PDP8L

Engineering Change Order Log

ECO SYNOPSIS FOR LOGIC OR OPTION
PDP-8L PROCESSOR LOGIC **PDP-8L**

ONLY FCO'S WRITTEN TO THE "PDP8L" OPTION ARE DOCUMENTED ON THIS FICHE.

D - BS - 86 - 0 - 6

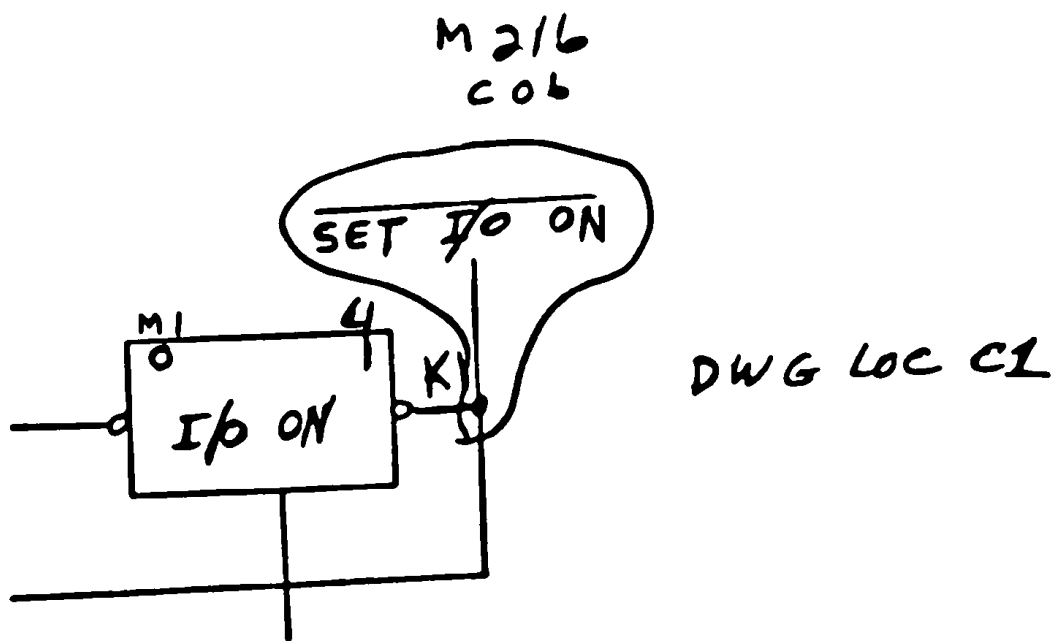
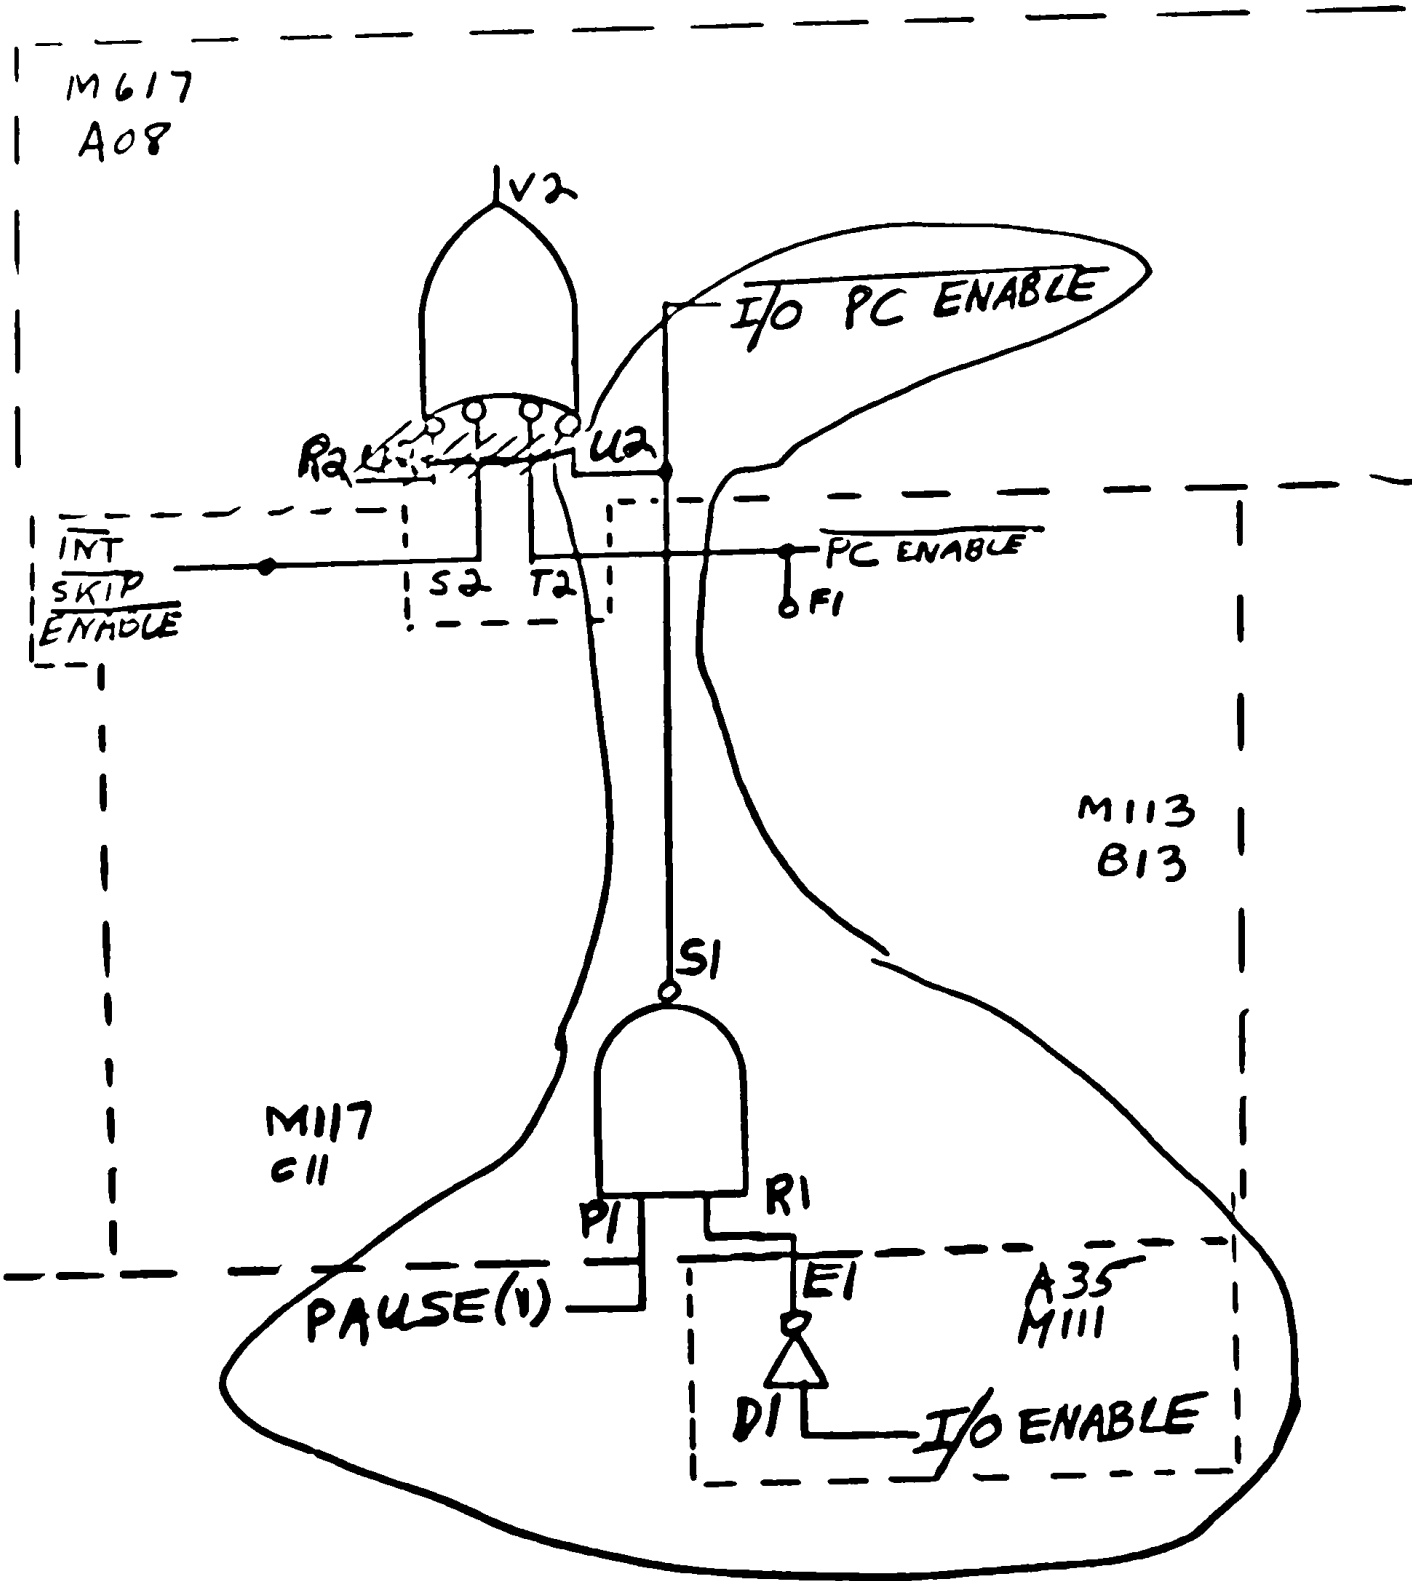
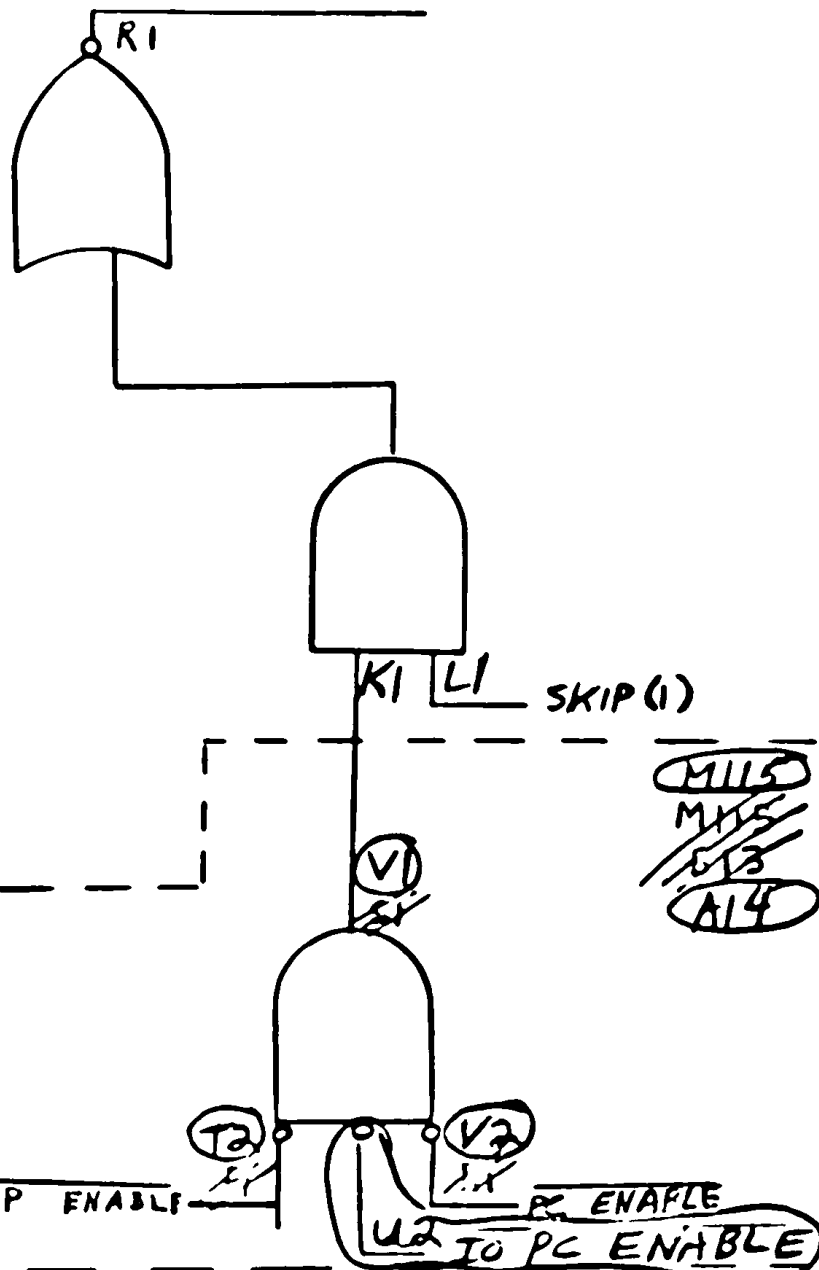
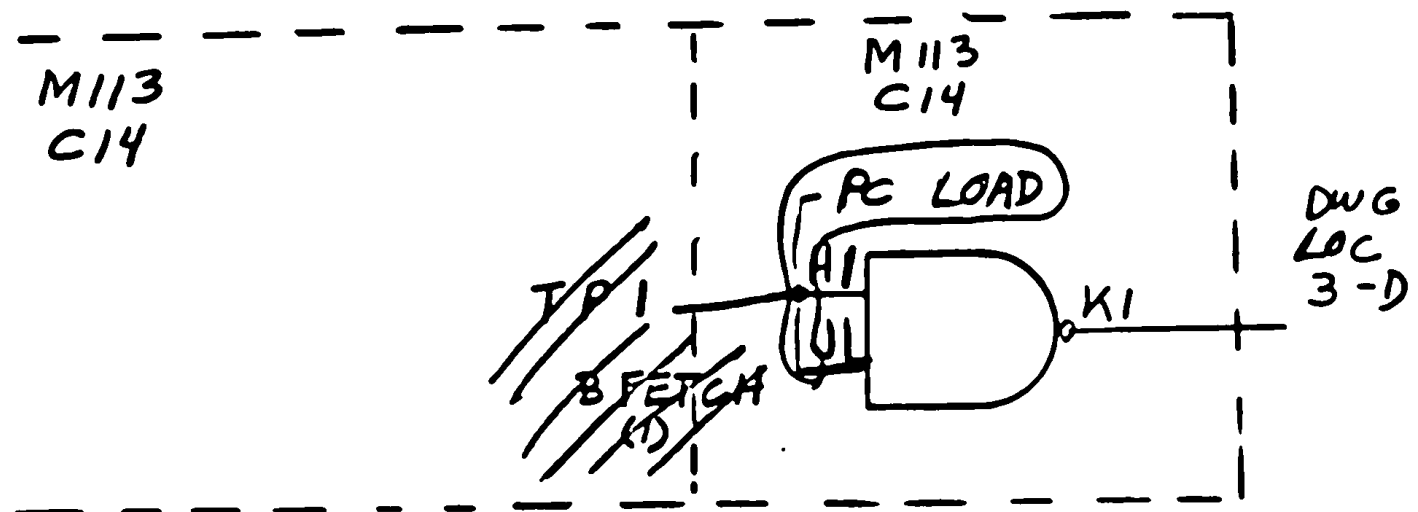
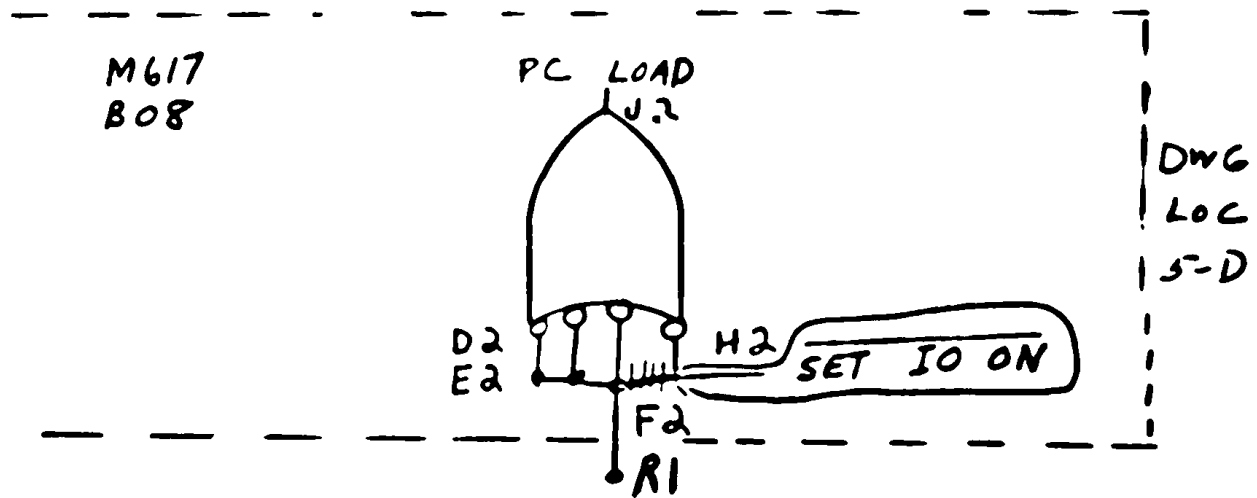
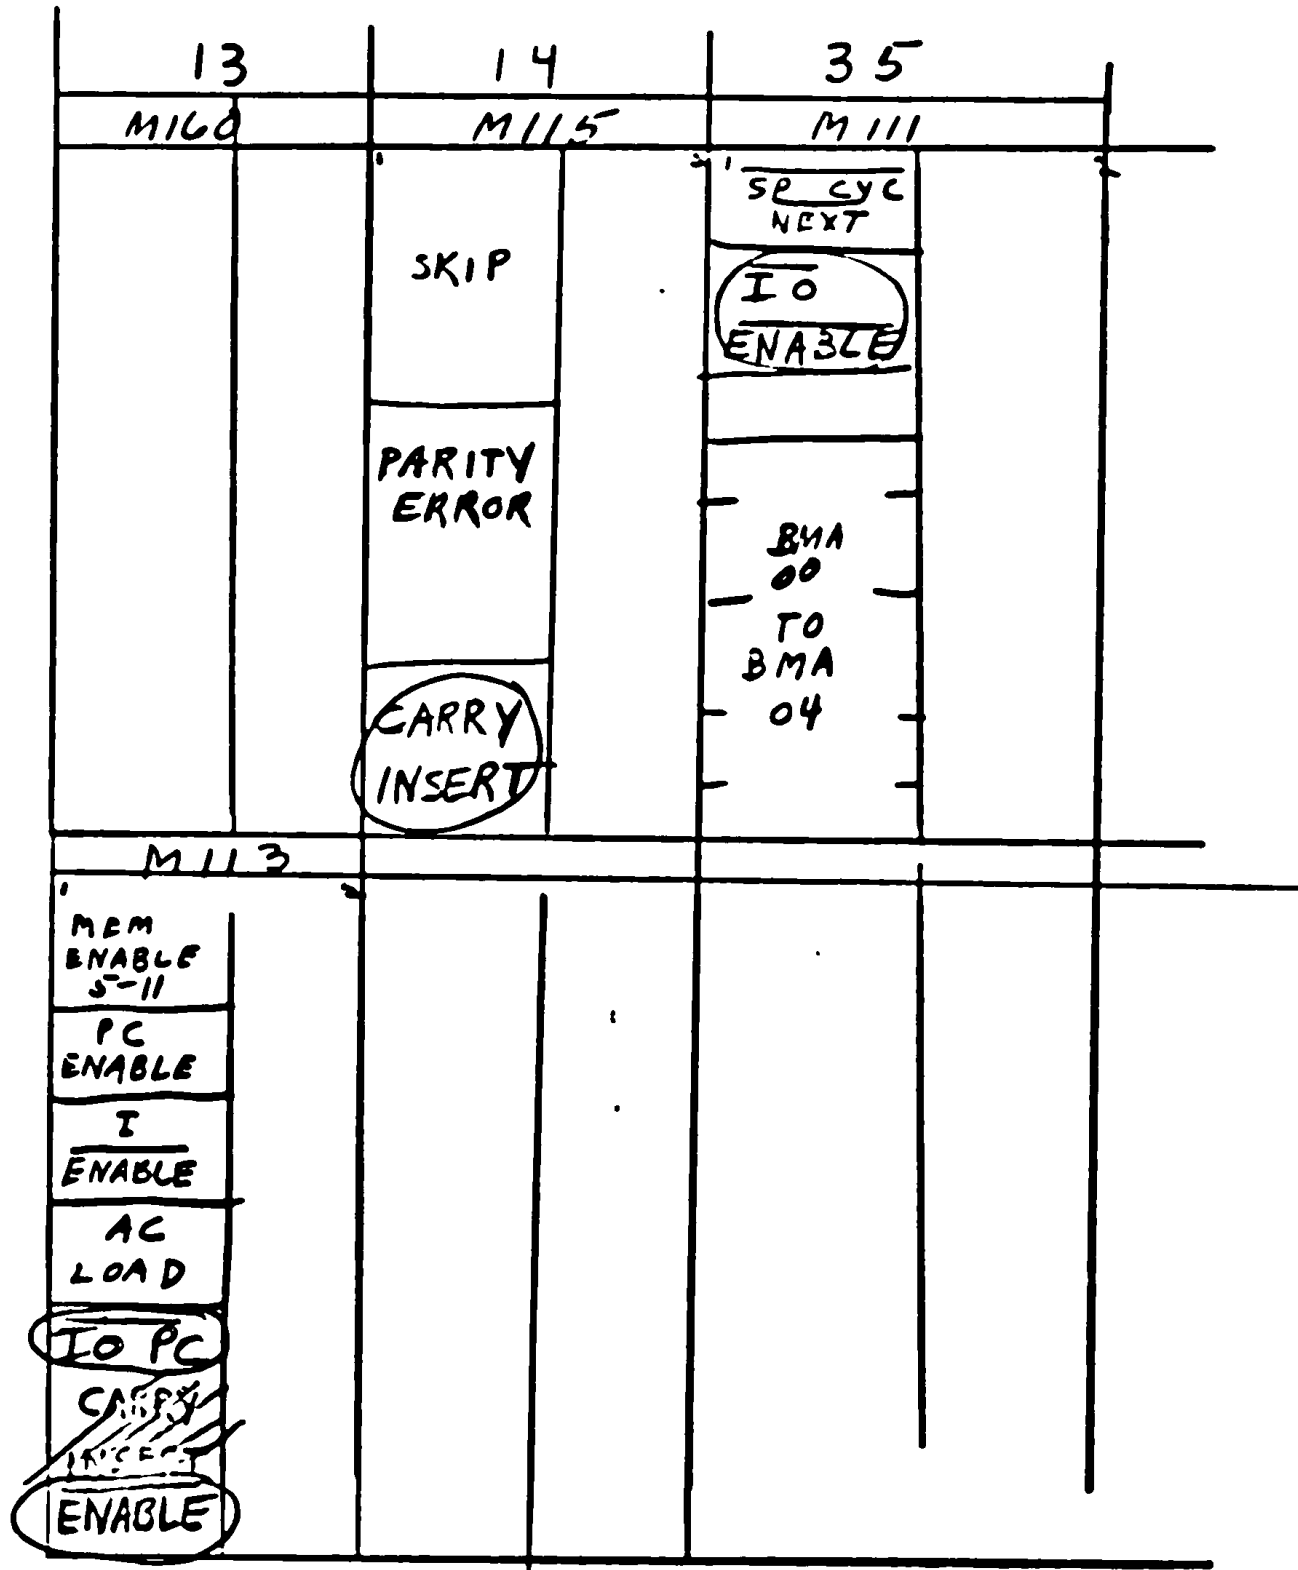
CHANGE AS PER LOGIC PRINTS TO ALLOW FAST FLAG TESTING IN PERIPHERALS.

CHANGE NO. EL-00059

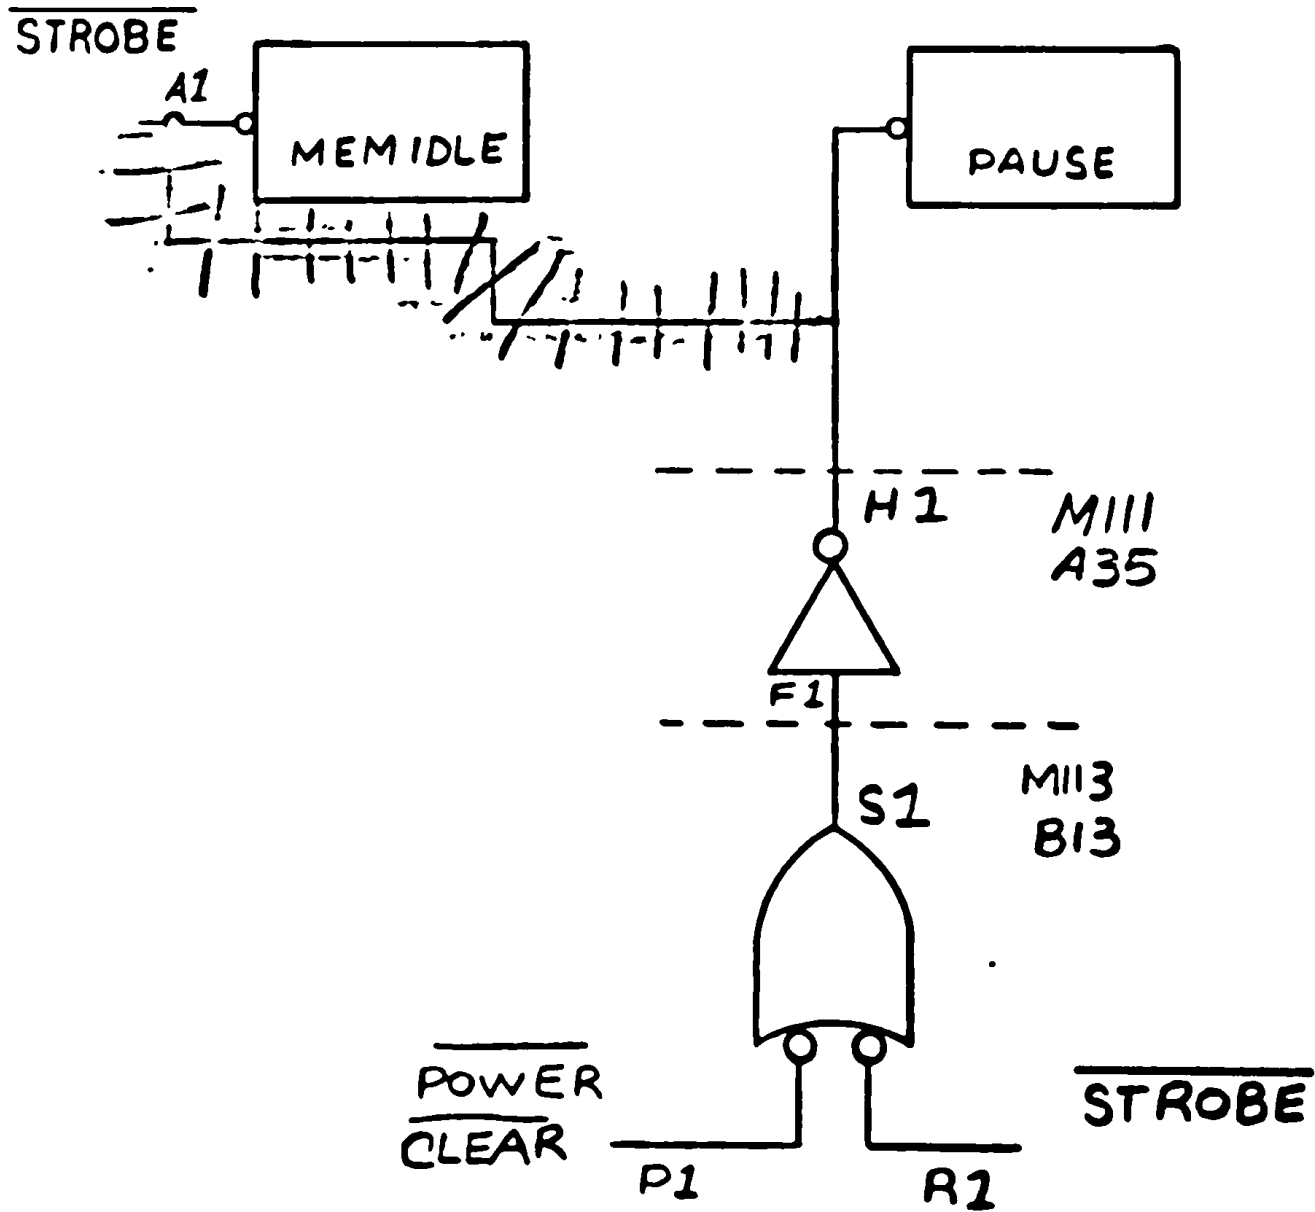
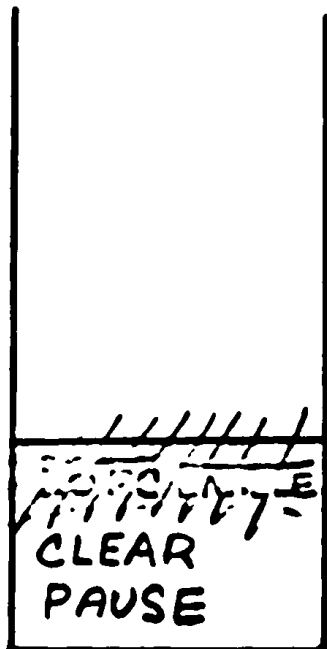
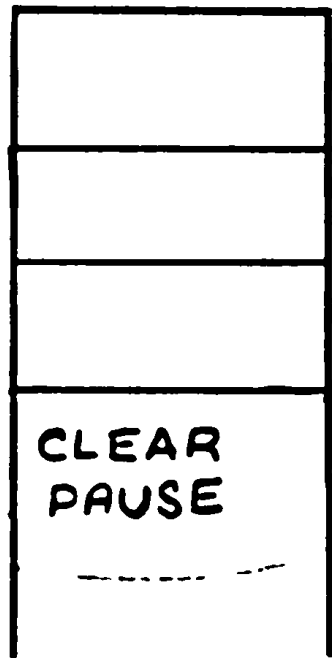
PROBLEM: THE PAUSE P.F. CAN COME ON IN EITHER STATE WHEN THE COMPUTER IS FIRST TURNED ON. IF IT COMES UP IN THE "I" STATE, LOAD ADD HAS TO BE HIT TWICE BECAUSE THE PAUSE INHIBITS PC ENABLE.

CORRECTION: ADD POWER CLEAR TO PAUSE P.F.

D-BS-8L-0-2 NEW REV K

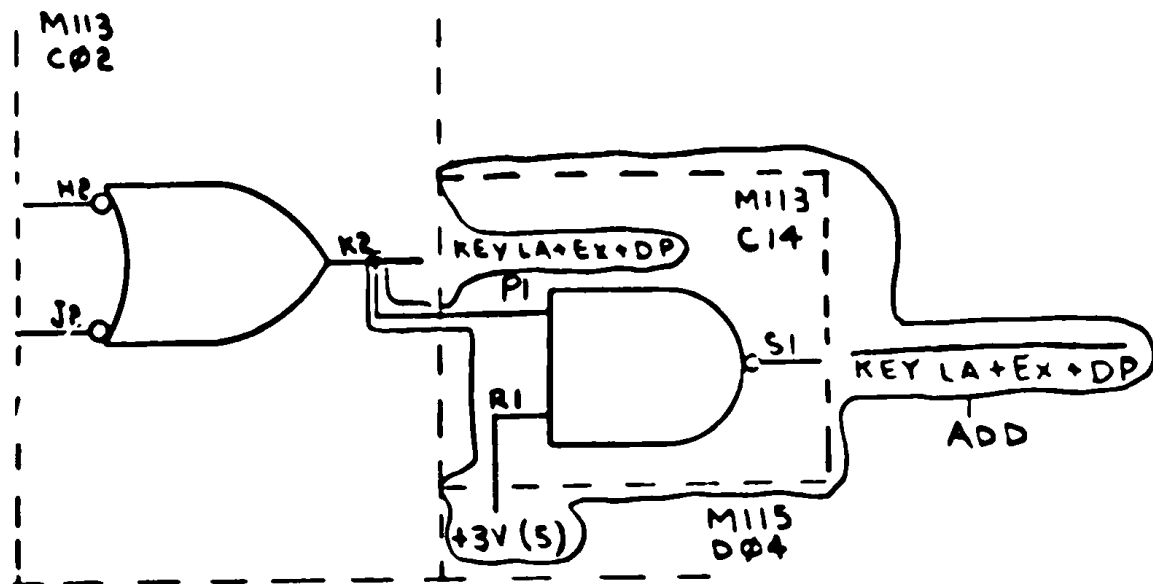
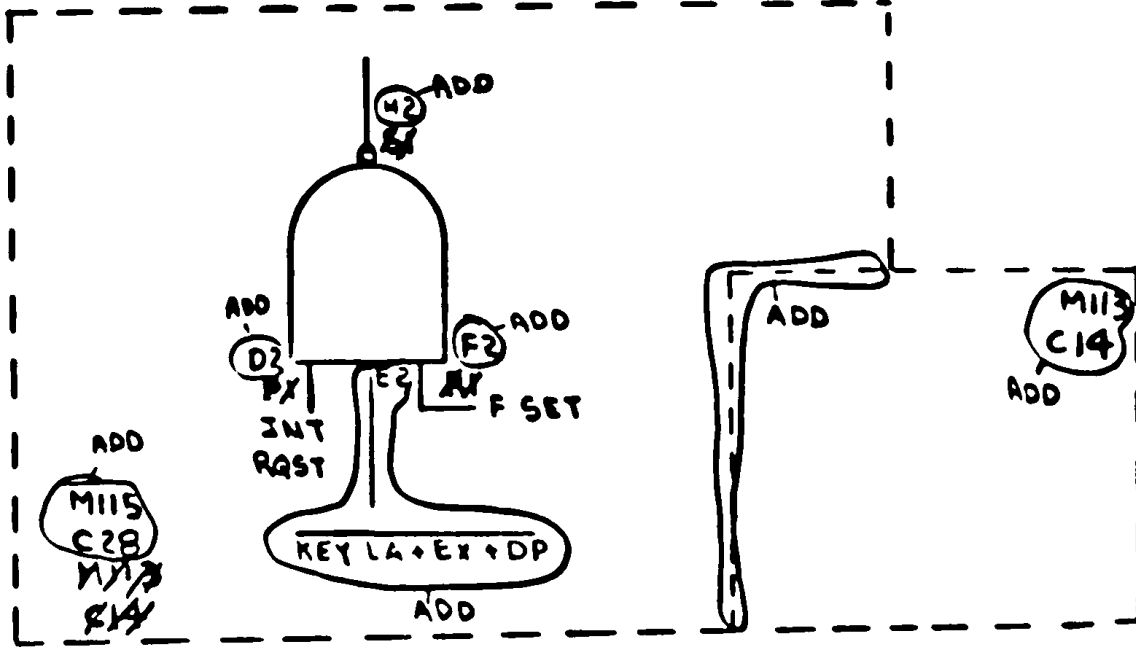
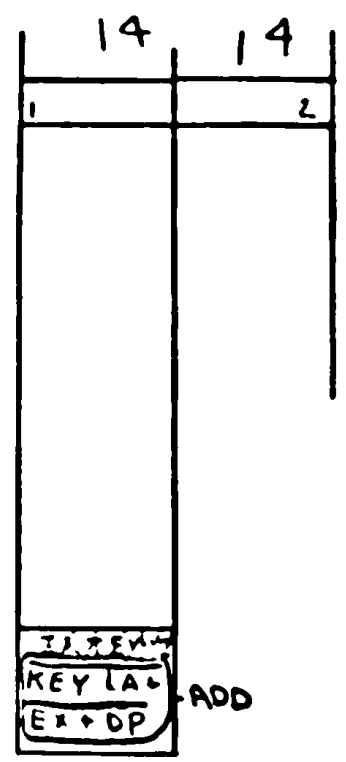
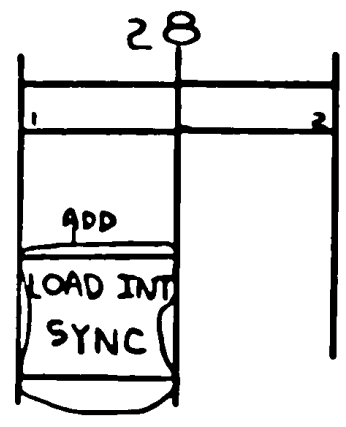
UNIT NAME		PDP-8L	MODEL NO.	8L
PREV RFD OPTIONS AFFECTED		CHANGE TESTED PROTO BY M. ARSENAULT		BREAK-IN POINT (DATE/SERIAL NO)
MODEL NO	VARIATION	ESTIMATED TIME TO INSTALL	30 MIN.	
		PARTS ADDED OR DELETED (IF YES REFER TO SEPARATE SHEET)	YES	NO
		SHOP MODEL AFFECTED	<input type="checkbox"/>	<input checked="" type="checkbox"/>
		SYSTEMS PROGRAMS AFFECTED	<input type="checkbox"/>	<input checked="" type="checkbox"/>
		DIAGNOSTIC PROGRAMS AFFECTED	<input type="checkbox"/>	<input checked="" type="checkbox"/>
		TECHNICAL PUBLICATIONS AFFECTED	<input type="checkbox"/>	<input checked="" type="checkbox"/>
FIELD MODIFY IF PROBLEMS EXISTS WITH EXTENDED MEMORY AND MANUAL FUNCTIONS			S.N. 1800 THRU 2054 AND FUTURE.
